Planning Commission Regular Meeting

Monday, July 27, 2026, 6:30 PM
106 Center Street

Item 88 First Street – Application for Variance

Re: Item 4(b) 150 Bell Street – Application for RRP
Date: July 27, 2026
From: Jess Long, Planner and Julia Mullin, Community Development Director

1
A2 **ARCHITECTURAL SITE PLAN**
1" = 10'-0"

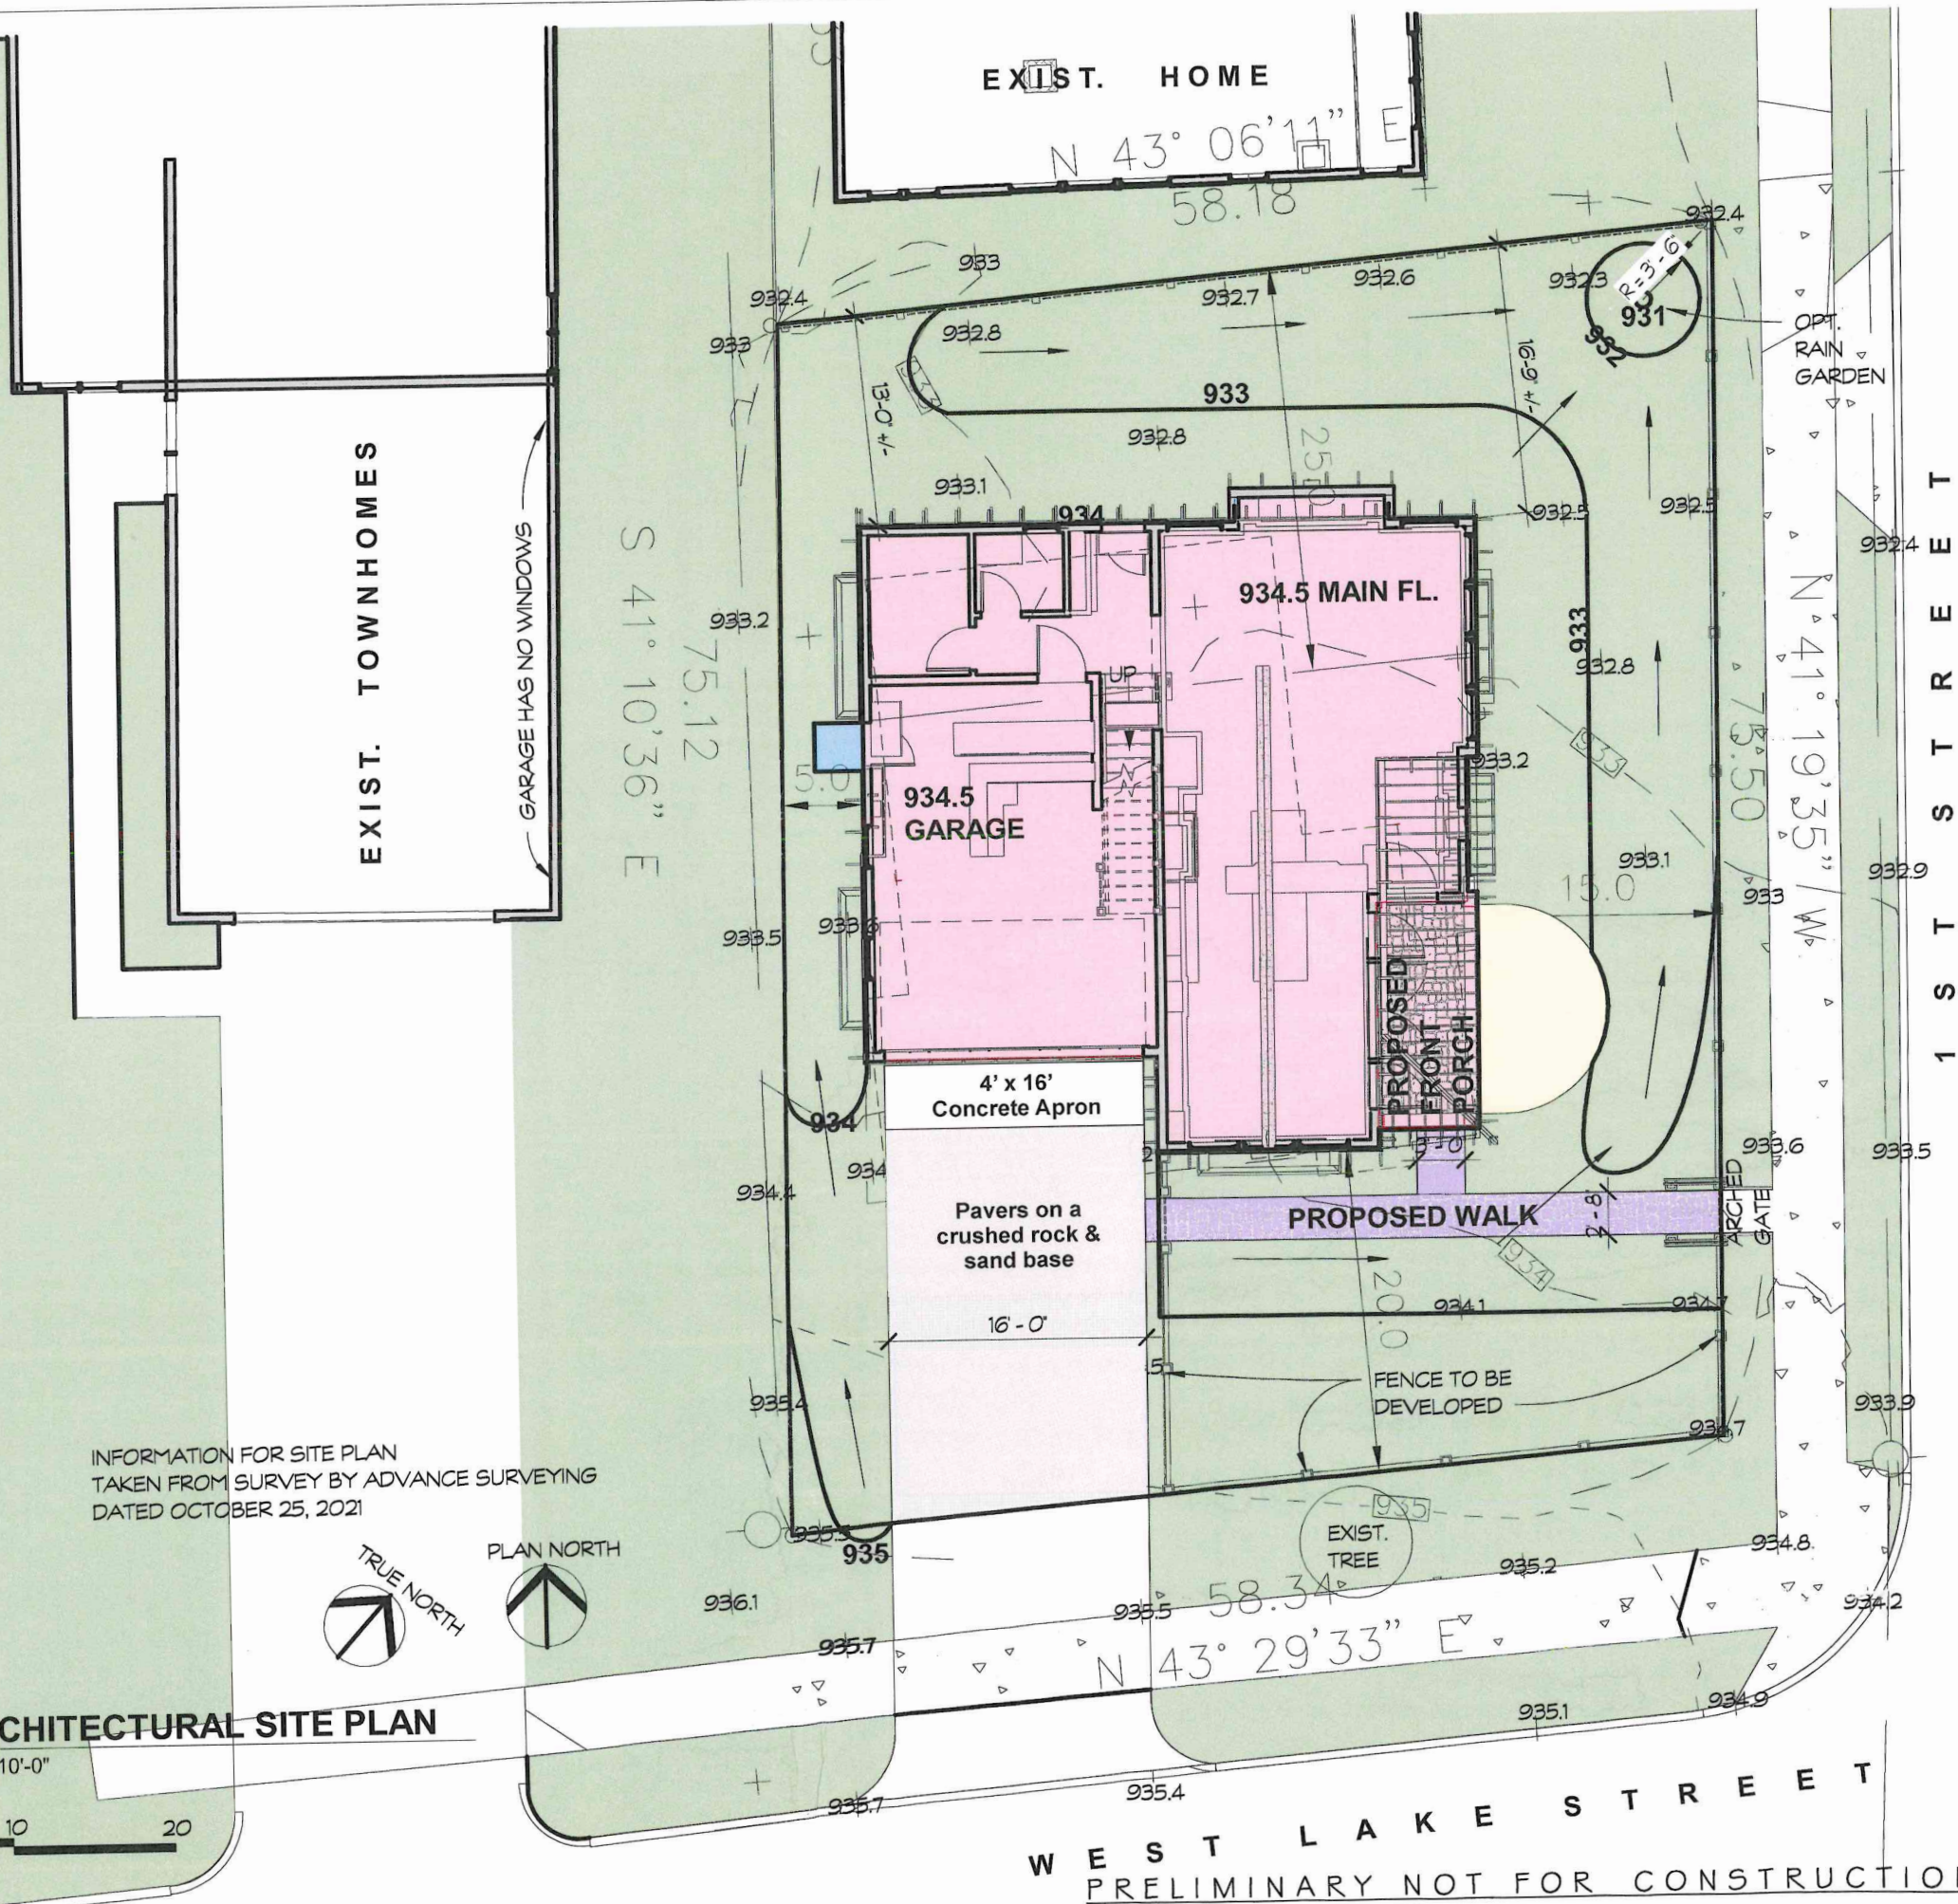
The current lot is under construction, and when completed the proposed home and paths will create lot coverage of 1,835 sq ft or 42% which is the maximum allowed by city ordinance. If a full driveway is installed the lot coverage will increase to 2,036 sf (46.6% of the parcel). The applicant requires a variance of 201 sq ft. This parcel is very small and the proposed home and other lot coverage additions have been reduced to minimize the impact on the lot. While the lot is unique the need for a variance is caused by the landowner's request to expand the already approved ribbon driveway. The criteria is not met.

HOUSE & GARAGE	1378 SQ. FT.
	WALK	111 SQ. FT.
	DRIVEWAY	451 SQ. FT.
	ALT. FOR RIBBON DRIVEWAY	250 SQ. FT.
	PATIO	87 SQ. FT.
	GARAGE STOOP	9 SQ. FT.
TOTAL HARDCOVER AREA OF LOT		2036 Sq.Ft.
		4368 Sq.Ft.
% OF HARDCOVER W/ FULL DRIVE		46.6%
TOTAL HARDCOVER W/ RIBBON DRIVE		1835 SQ. FT.
% OF HARDCOVER W/ RIBBON DRIVE		42%
BUILDING COVERAGE		31.5%

The Planning Commission shall hold a public hearing for the Variance application. Staff recommends that the Commission should recommend to the City Council that they deny the variance application.

Figure 1 Site Plan with dimensions prepared by City Architect

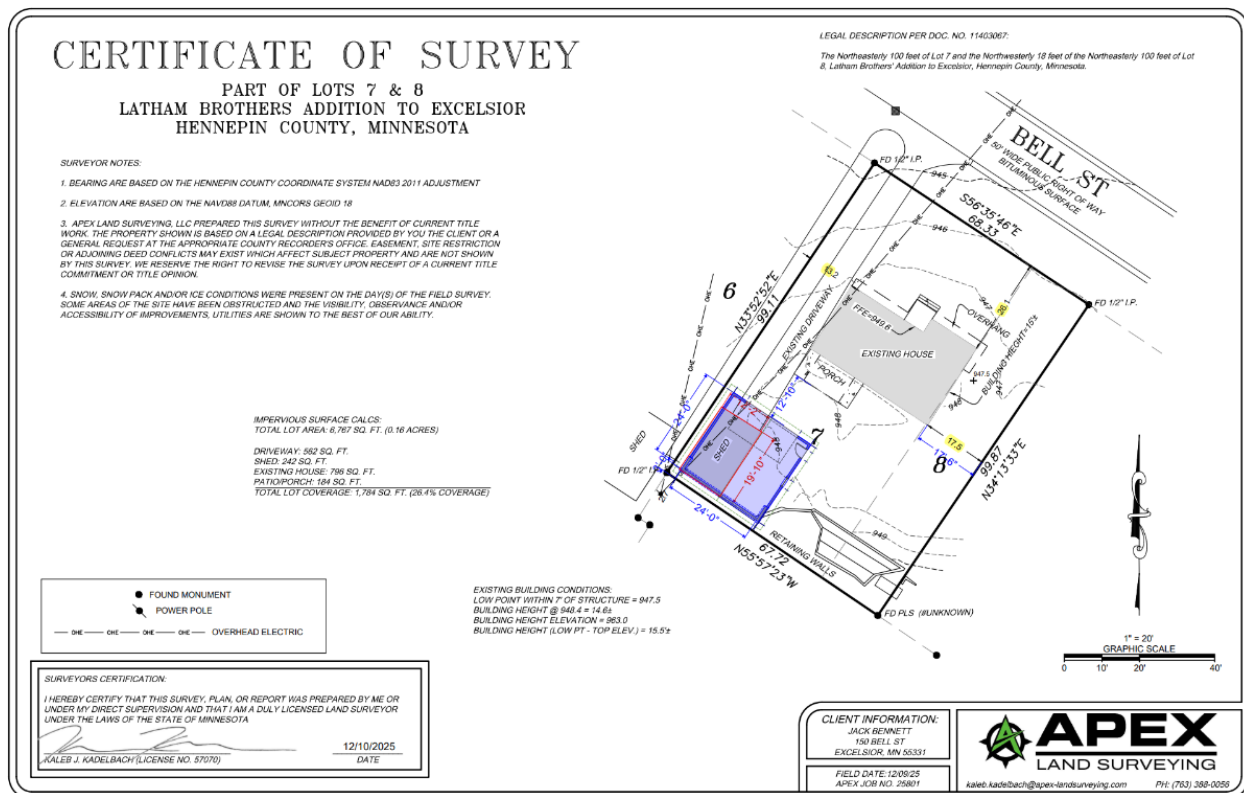
The proposed garage will be near the existing retaining wall. The applicant will need to verify if the retaining wall will be impacted by the project. Changes to the retaining wall will require engineered plans reviewed by the City Engineer.

2. The applicant shall submit survey with proposed lot coverage and building coverage calculations prior to issuance of building permit and staff will verify that they conform with zoning standards.
3. The RRP shall expire one year from the date of adoption of the resolution if not acted upon.
4. The applicant shall submit any grading or retaining wall designs to the City Engineer for review.

150 Bell st
Proposed Garage

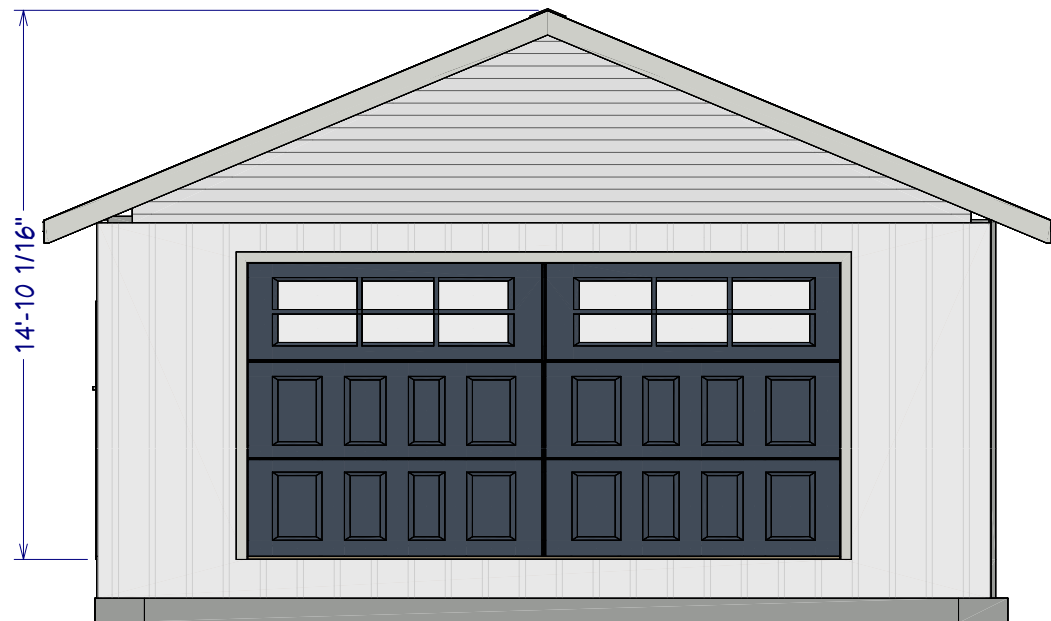
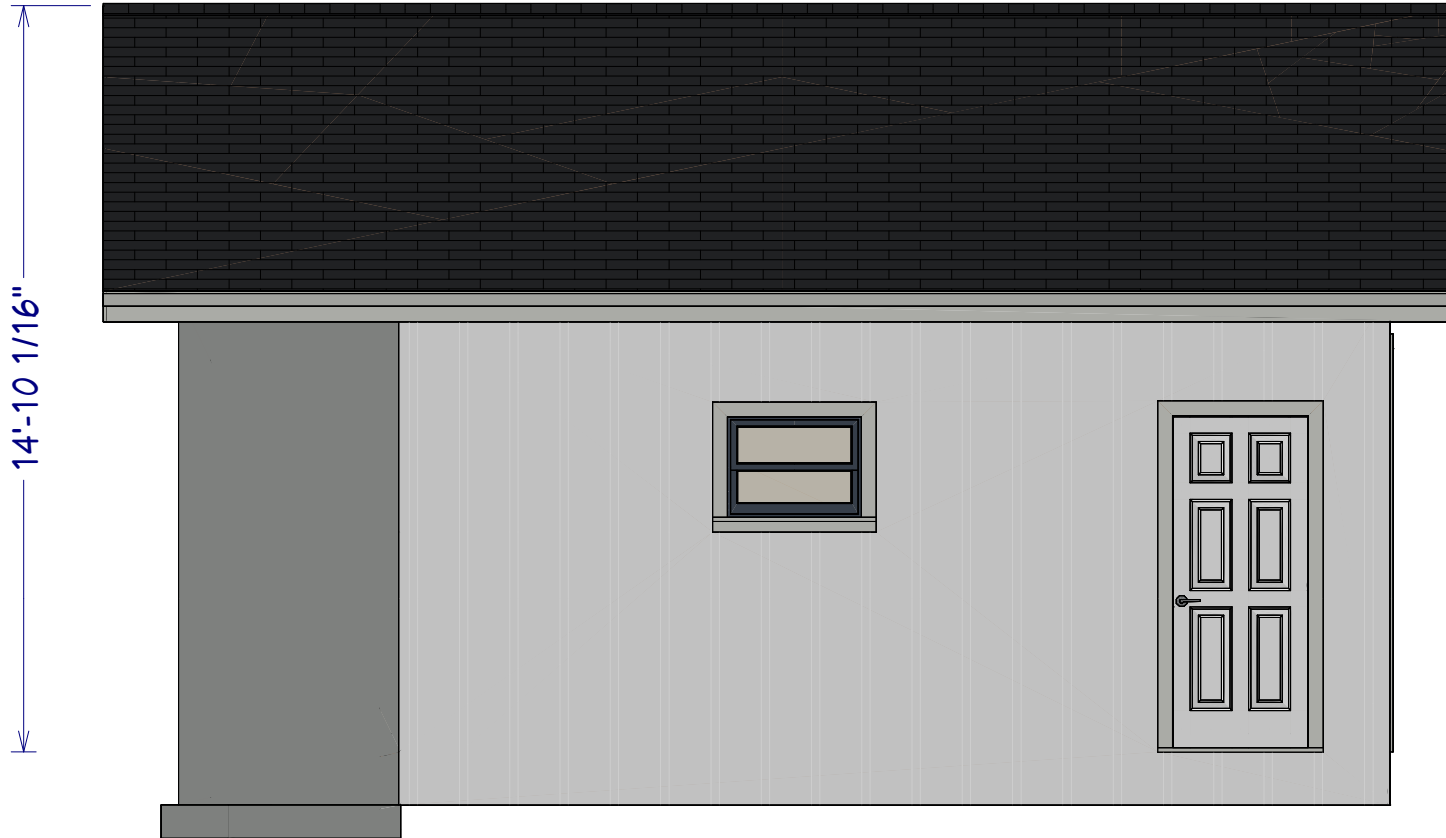
The project proposes demolishing an existing rear-yard single stall garage (plan dimensions about 12-0 x 20-0) and replacing it with a new two-stall garage (plan dimensions about 24-0 x 24-0, with a 14-10 high gabled roof). The existing driveway will continue to be used to access the garage. The extent of proposed new driveway paving connecting to the garage is unclear from the application materials. It appears the location and size of the proposed garage results in only about 13-4 from garage door to existing house's rear porch, possibly limiting vehicular access to the full width of the garage. Applicant should clarify and provide an accurate site drawing indicating proposed paving and coverages.

The site has a steep grade up in the rear yard with an extensive retaining wall. Drawings do not clearly show how the proposed structure and retaining wall intersect. Applicant should clarify how retaining wall and garage relate to each other, and how grades and drainage are managed around the rear of the garage.

Garage should have siding types and consistent with main house and window and corner details also consistent. Drawings are unclear about these siding materials and details; applicant should clarify what is intended. No windows are indicated in plan at one side or rear elevations. Typically, four-sided design may indicate windows to be in two or all three of the non-garage door elevations, but considering the location of this garage and the obscured visibility of the side and rear elevations, a single window on the door side elevation may be acceptable. The small horizontal window shown, however, should be larger and more vertically proportioned to be consistent with window proportions of the house.

The side elevation indicates a full-height gray area at rear of garage. This should be explained by applicant: is this gray area a proposed material change, or is it related to grade and retaining walls? No rear or opposite side building elevations are provided to indicate what materials and detailing are proposed here. Applicant should clarify.
